## **ADDENDUM NO. 1**

**PROJECT:** Three Mile Lane Pump Station No. 3  
**J.O.:** 11110199  
**OWNER:** City of McMinnville, Oregon  
**LOCATION:** McMinnville, Oregon  
**FROM:** GHD, Inc.  
**DATE:** September 22, 2016

Client: CITY OF MCMINNVILLE, OREGON  
Project: THREE MILE LANE PUMP STATION NO. 3  
Title: ELECTRICAL PANEL AND CIRCUIT SCHEDULES  
Contract No. 11110199  
Drawing No: E4  
Sheet: 27 of 29  
Rev: E4

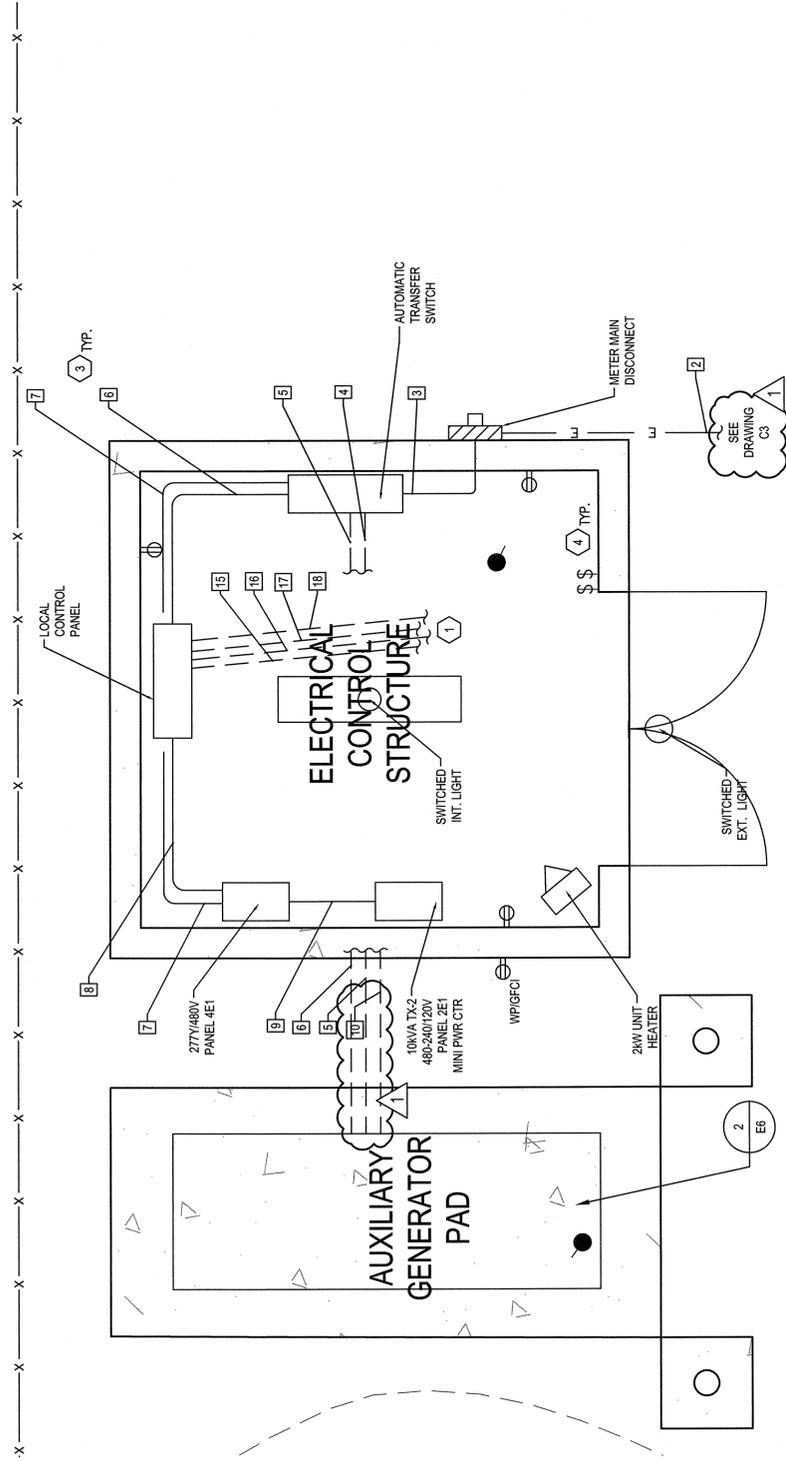
#### **Plan Sheets E2, E3 and E4**

Several edits were completed to these sheets including Panel, and Conduit & Conductor Schedules. The changes have been clouded on the revised plan sheets. A copy of the revised sheets are included as an attachment to this addendum.

**8) The transformers and conduit are called out on the Conduit & Conductor Schedule sheet E-4 but not shown on the plans.**

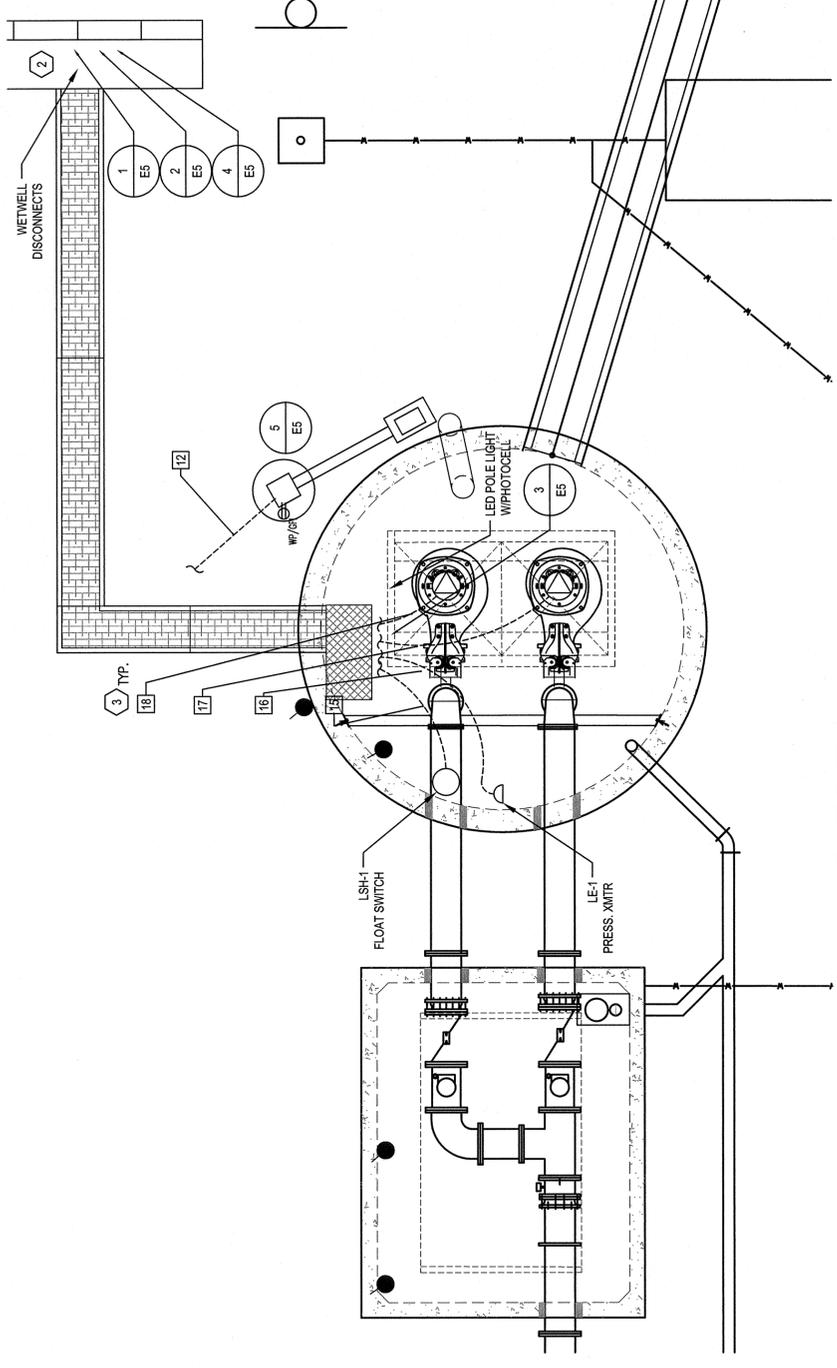
#### **Plan Sheets C3-C5, EC1, M1 and E3**

2. The plan views on multiple sheets including those noted in the title of this comment, show a foot print for the “Electrical Control Structure” that scales to approximately 10’x10’. The plan view outlines on these or similar drawings, for this item only, should be considered approximate. The required foot print of the concrete pad to support the structure is shown in detail 3/C7 and is to provide a minimum of 1’=0” additional width beyond the outside walls or eaves of the Pre-Fabricated Fiberglass Shelter. Technical Specification Section 13 34 24 *Prefabricated Fiberglass Shelter*, identifies a building size to be 6’ x 6’ x 7.5 (W x L x H) at the eaves or back wall.
